D C3D.dwg – Layout Tab: C1.0 TITLE SHEET

THE VILLAGES AT
GRANTS FR
SECTION TWO, BL
MILITARY SURVE
VILLAGE OF SOU
WARREN COU

Drawing:	11C009-003 CD C3D
Drawn by:	TAC
Checked By:	GJK
Issue Date:	03-11-15
Sheet:	C2.0

CURB RAMP DETAIL

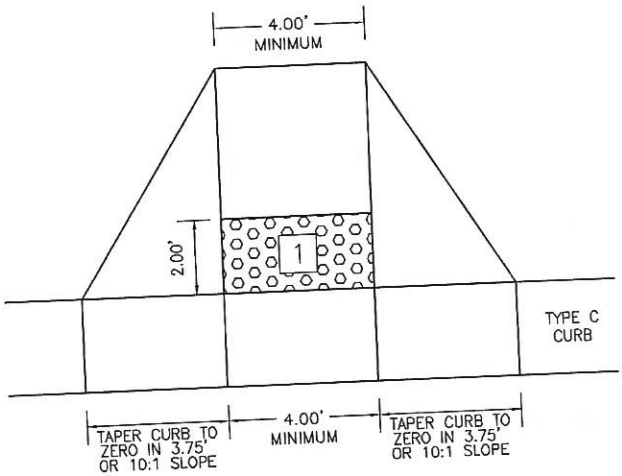
BP-7,1??

[1] DETECTABLE WARNING (TRUNCATED DOMES) ARE TO BE INSTALLED IN THE LOCATION SHOWN. DIMENSIONS OF THE DOMES ARE 24' FROM THE BACK OF THE CURB BY THE WIDTH OF THE RAMP.
(TRUNCATED PANEL BY ADA SOLUTIONS OR APPROVED EQUAL). Color shall be red, as approved by the Village

TYPICAL SECTION

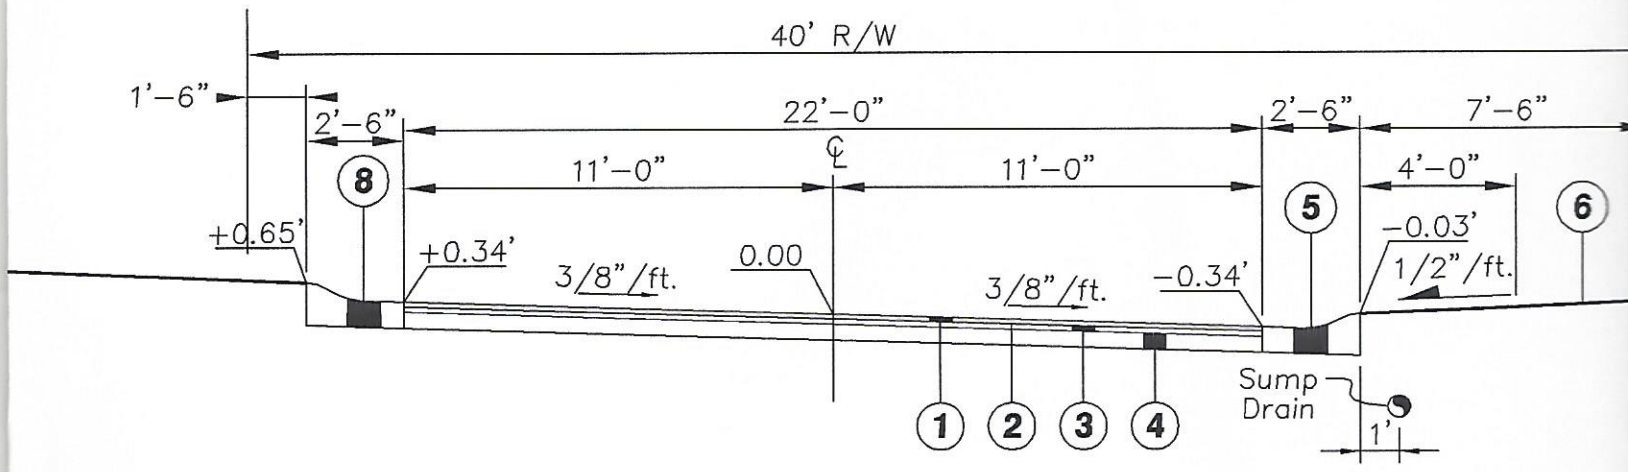
FREDERICK COURT ← Stations?

FREDERICK TRAIL ← Stations?

1. ITEM ~~404~~ 441 –(1 1/2") ASPHALT CONCRETE SURFACE COURSE
2. ITEM 407–TACK COAT MS–2, RS–1, OR RC–250
3. ITEM ~~448~~ 441 –(1 1/2") ASPHALT CONCRETE LEVELING COURSE
4. ITEM 301–(5") ~~COURSES BITUMINOUS AGGREGATE BASE~~ Asphalt Concrete Base, PG64-22
5. CURB & GUTTER, TYPE "C" (WARREN COUNTY STANDARD)
6. PROVIDE (4") MIN. TOPSOIL SEED & MULCH OR SOD.
7. ITEM 608–(4") THICK CONCRETE SIDEWALK, 4' WIDE, TO BE 1/2" HIGHER THAN SOD.

1. ITEM ~~404~~ 441 –(1 1/2") ASPHALT CONCRETE SURFACE COURSE
2. ITEM 407–TACK COAT MS–2, RS–1, OR RC–250
3. ITEM ~~448~~ 441 –(1 1/2") ASPHALT CONCRETE LEVELING COURSE
4. ITEM 301–(5") ~~COURSES BITUMINOUS AGGREGATE BASE~~ Asphalt Concrete Base, PG64-22
5. CURB & GUTTER, TYPE "C" (WARREN COUNTY STANDARD)
6. PROVIDE (4") MIN. TOPSOIL SEED & MULCH OR SOD.
7. ITEM 608–(4") THICK CONCRETE SIDEW 4' WIDE, TO BE 1/2" HIGHER THAN S
8. CURB & GUTTER, TYPE "C" MODIFIED

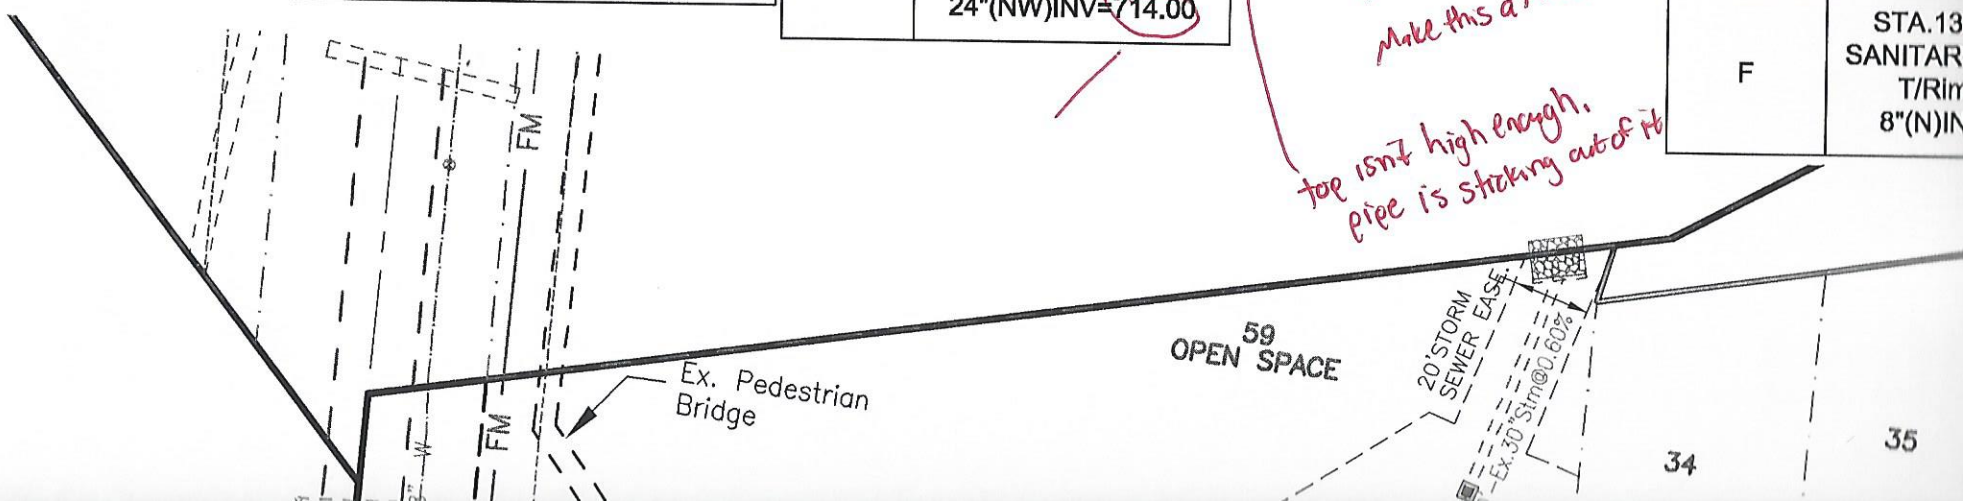
T/G for structures #1 and #2 should be the same

not enough cover

Offset way off

not enough cover

station wrong

station wrong

station wrong

headwall T/G?

T/G stands for what on a headwall?

standard A 2-2B cannot be 9' deep. Make this a M1 or 2-3.

toe isn't high enough. pipe is sticking out of it

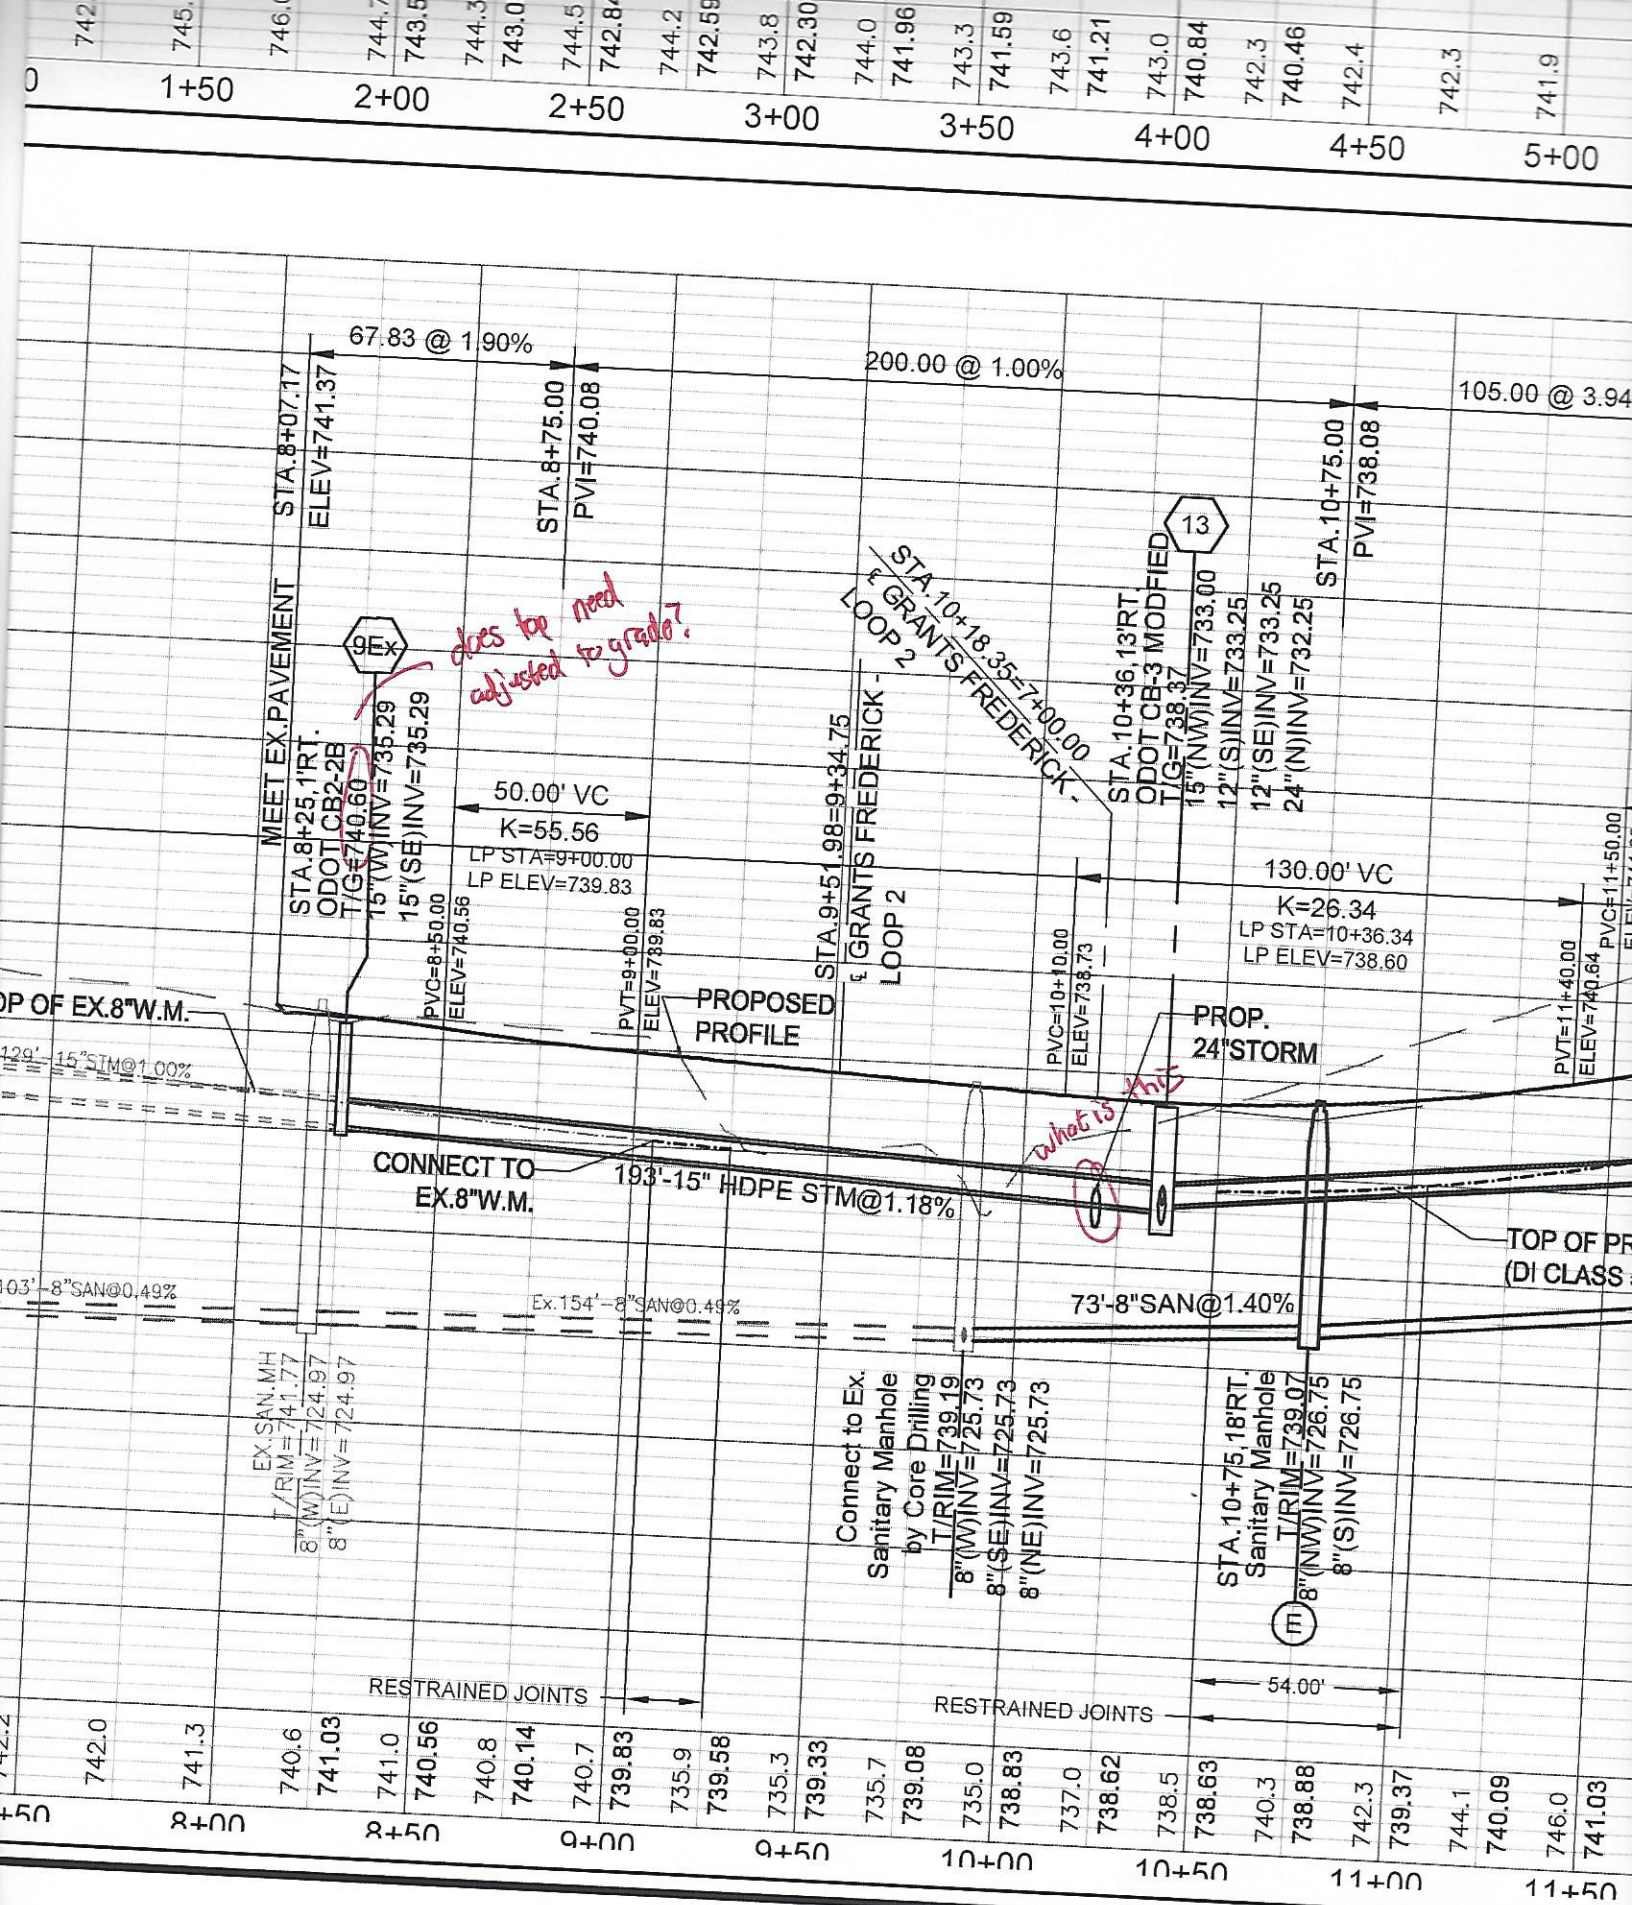
profile sagged at O

low point is at 10+36, How does water get to 10+68??

100' off?

100' off?

GRANTS FREDERICK

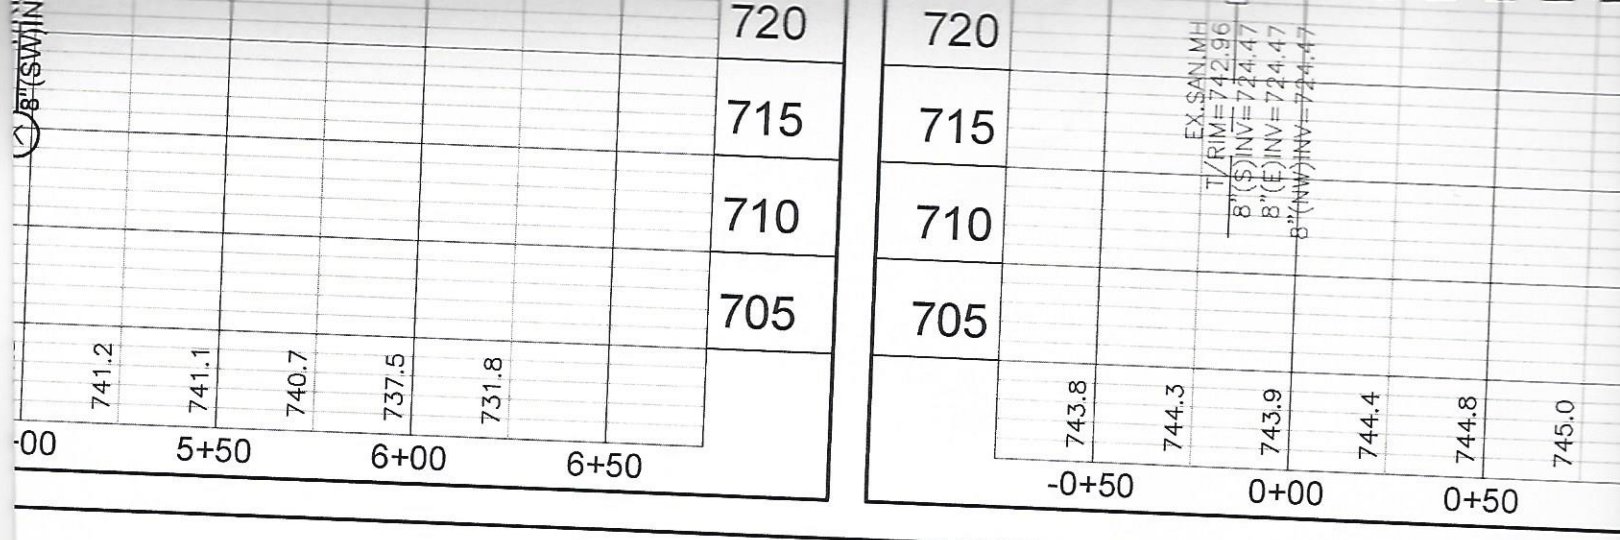
67.83 @ 1.90%
200.00 @ 1.00%
105.00 @ 3.94
STA.8+07.17
ELEV=741.37
STA.8+75.00
PVI=740.08
STA.10+18.35=7+00.00
℄ GRANTS FREDERICK
LOOP 2
STA.10+36.13'RT.
ODOT CB-3 MODFIED
T/G=738.37
15"(NW)INV=733.00
12"(S)INV=733.25
12"(SE)INV=733.25
24"(N)INV=732.25
13
STA.10+75.00
PVI=738.08
MEET EX.PAVEMENT
STA.8+25.1'RT.
ODOT CB2-2B
T/G=740.60
15"(W)INV=735.29
15"(SE)INV=735.29
9 Ex
does top need adjusted to grade?

130.00' VC
K=26.34
LP STA=10+36.34
LP ELEV=738.60
PROP.
24"STORM
what is this
PVT=11+40.00
ELEV=740.64
PVC=11+50.00
OP OF EX.8"W.M.
129'-15"STM@1.00%
CONNECT TO
EX.8"W.M.
193'-15" HDPE STM@1.18%
TOP OF PR
(DI CLASS
103'-8"SAN@0.49%
Ex.154'-8"SAN@0.49%
73'-8"SAN@1.40%
EX.SAN.MH
T/RIM=741.77
8"(W)INV=724.97
8"(E)INV=724.97
Connect to Ex.
Sanitary Manhole
by Core Drilling
T/RIM=739.19
8"(W)INV=725.73
8"(SE)INV=725.73
8"(NE)INV=725.73
STA.10+75.18'RT.
Sanitary Manhole
T/RIM=739.07
8"(NW)INV=726.75
8"(S)INV=726.75
11
RESTRAINED JOINTS
RESTRAINED JOINTS

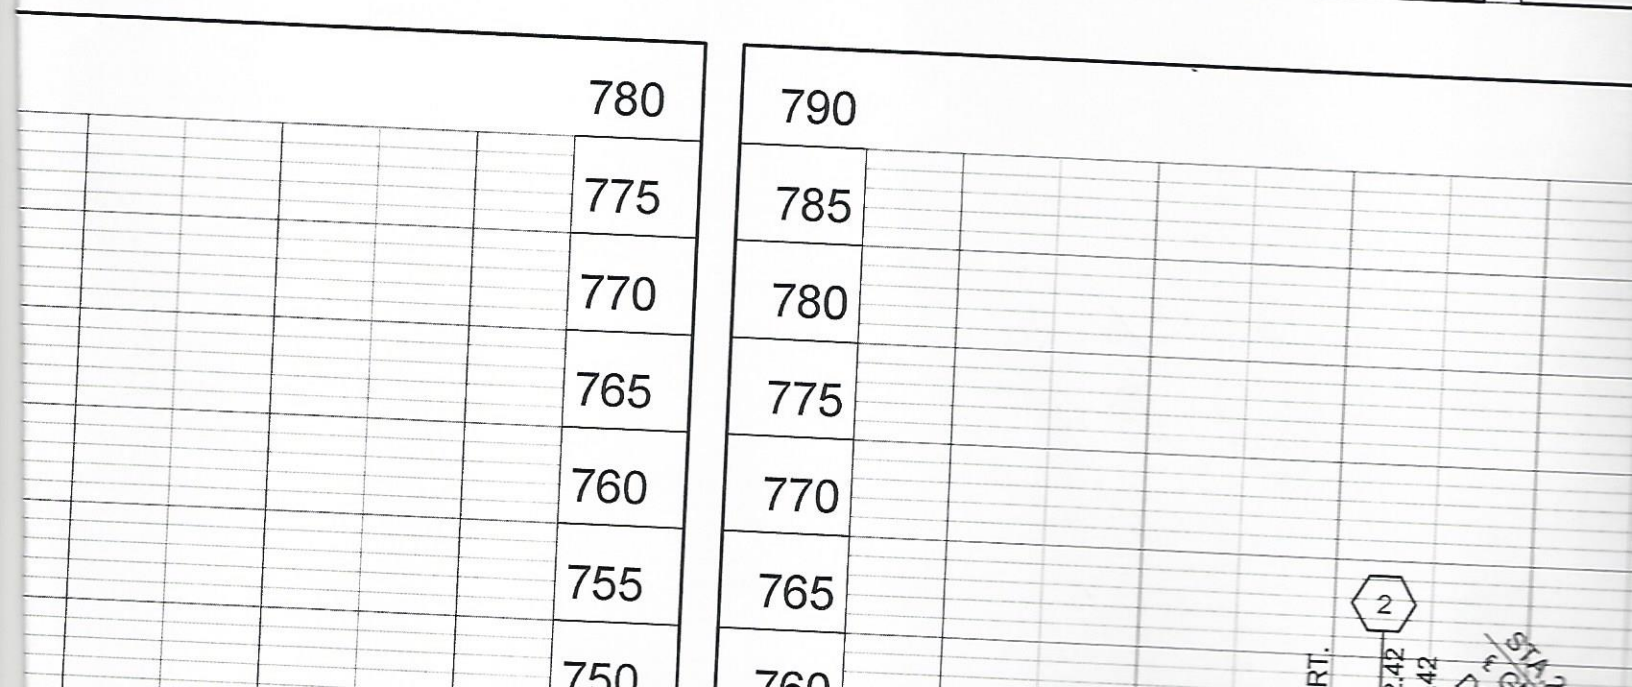
17
STA.4+74.27'RT.
ODOT CB-3
T/G=739.48
12"(E)INV=736.25
PROPOSED
PROFILE
18
STA.5+85.105'RT.
ODOT CB2-2B
T/G=725.39
12"(W)INV=721.00
12"(E)INV=716.50
doesn't connect
19
STA.8+42.81.208'RT.
ODOT HW-1
12"(W)INV=714.00
PROP.6"
W.M.
136'-12" HDPE STM@11.23%
EXISTING
PROFILE
130'-12" HPDE STM@1.92%
10'x4'x18"
R.C.P.
Type"C"
does not match
plan view
760
755
750
745
740
735
730
725
720
715
710
705

GRADING & ERO

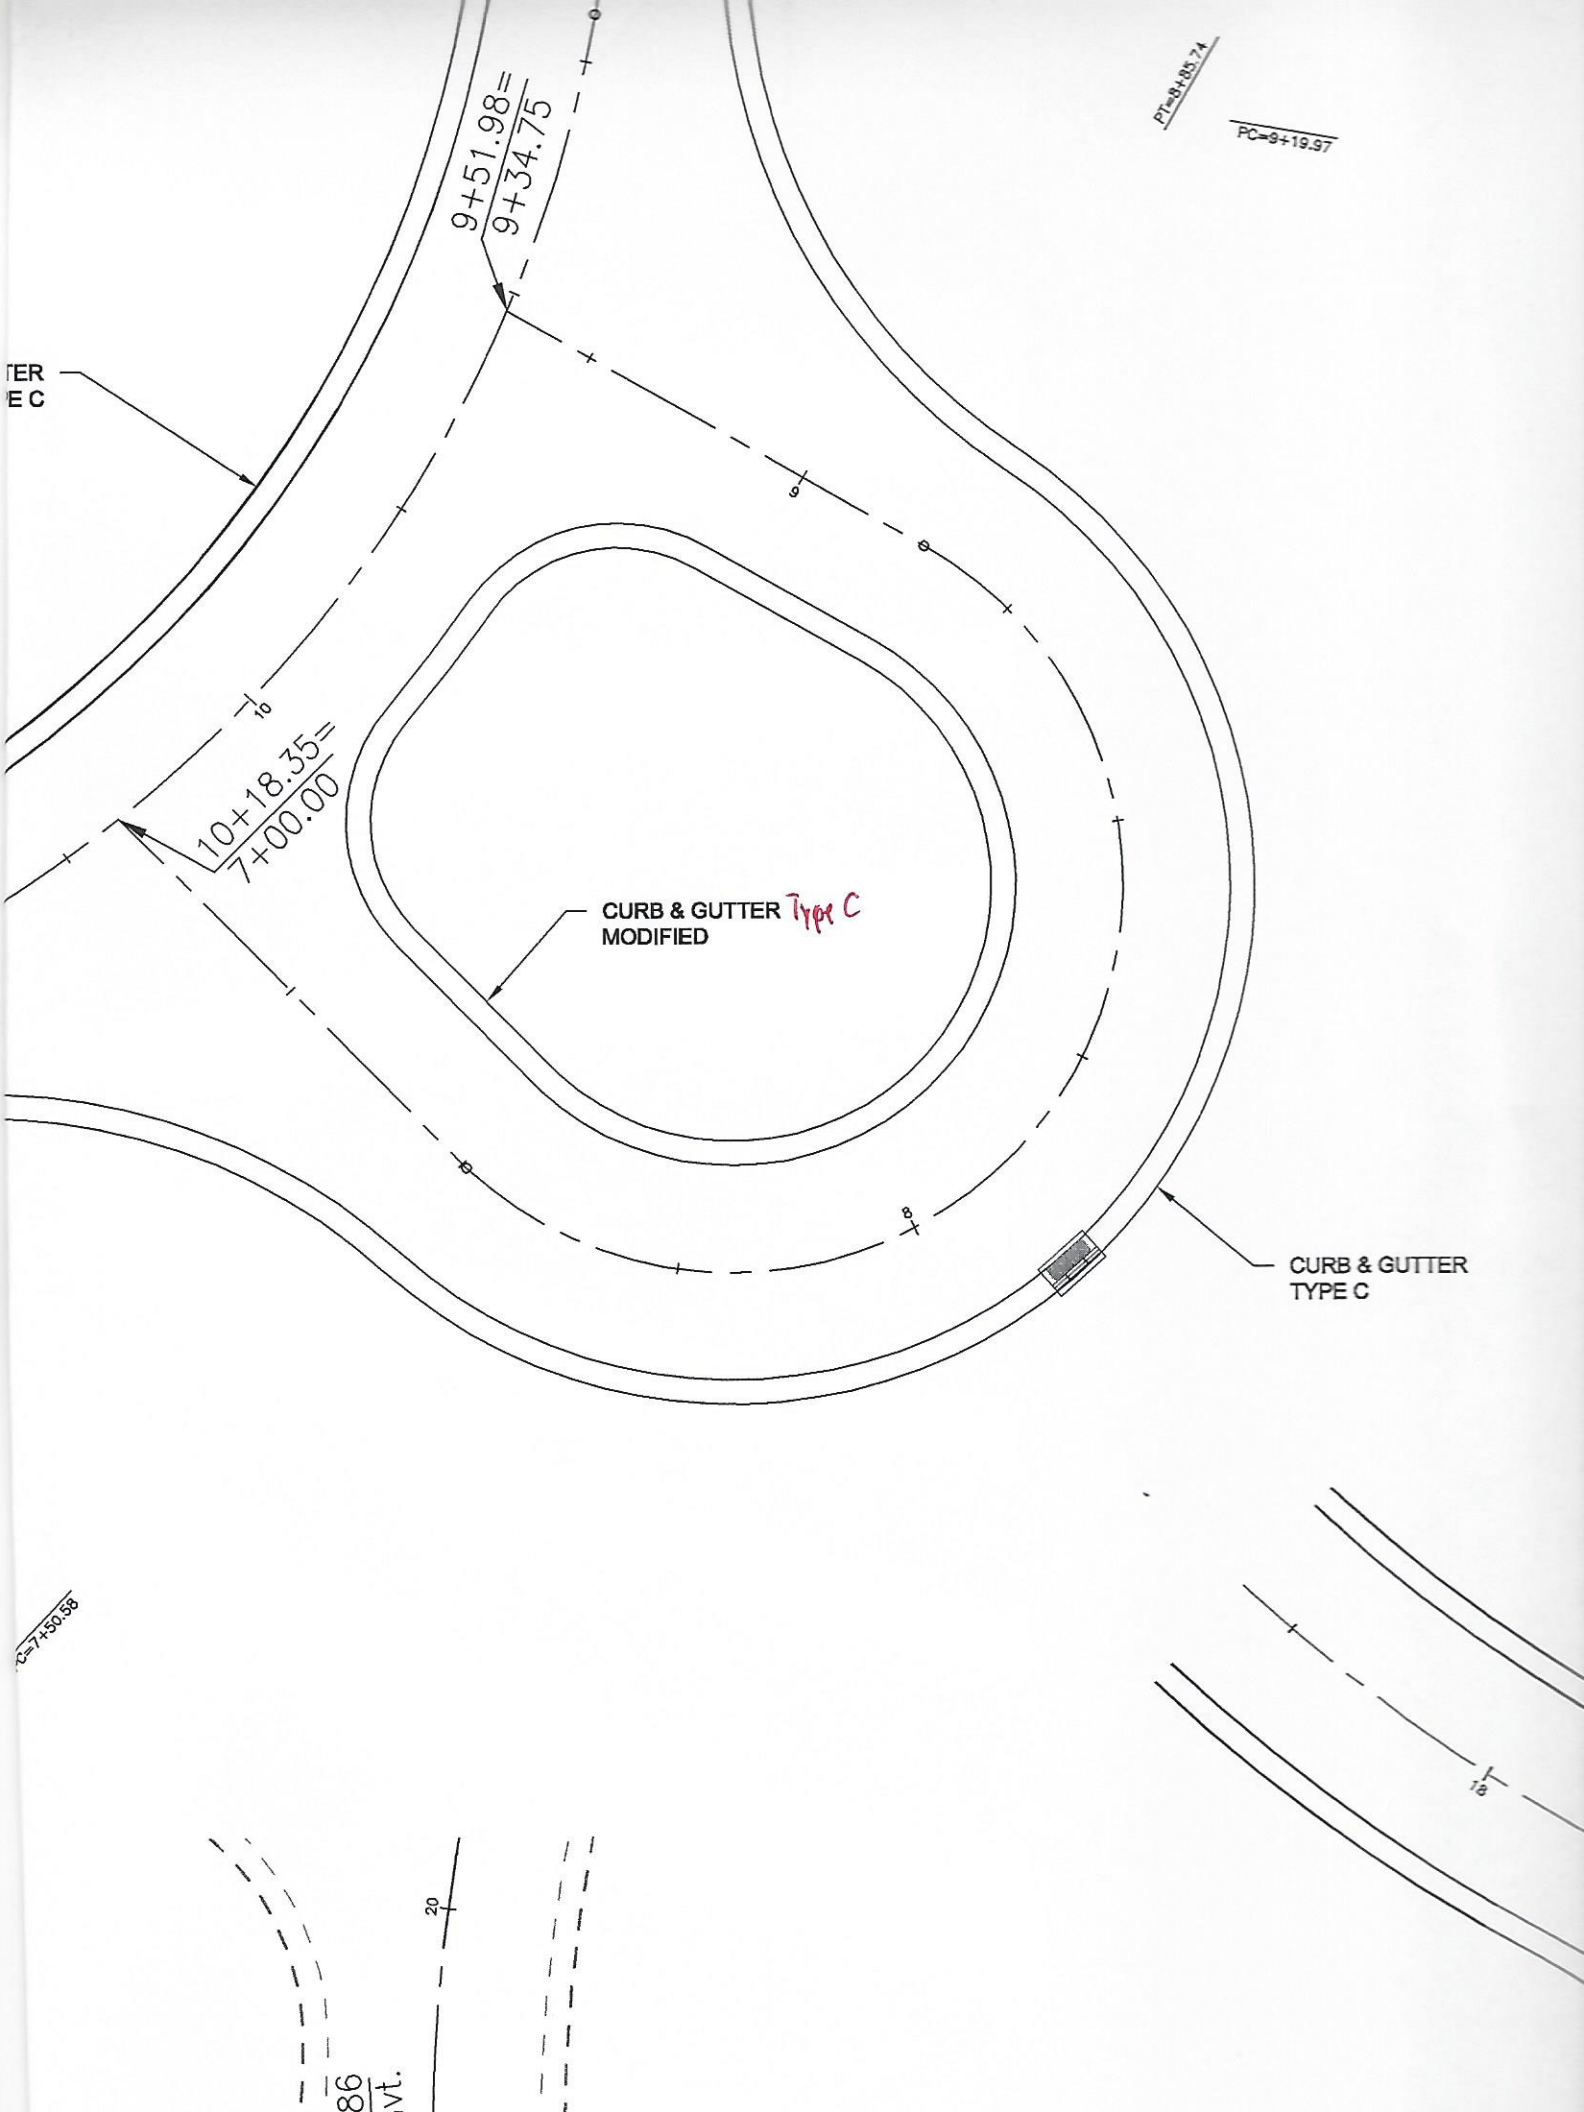
label
contours
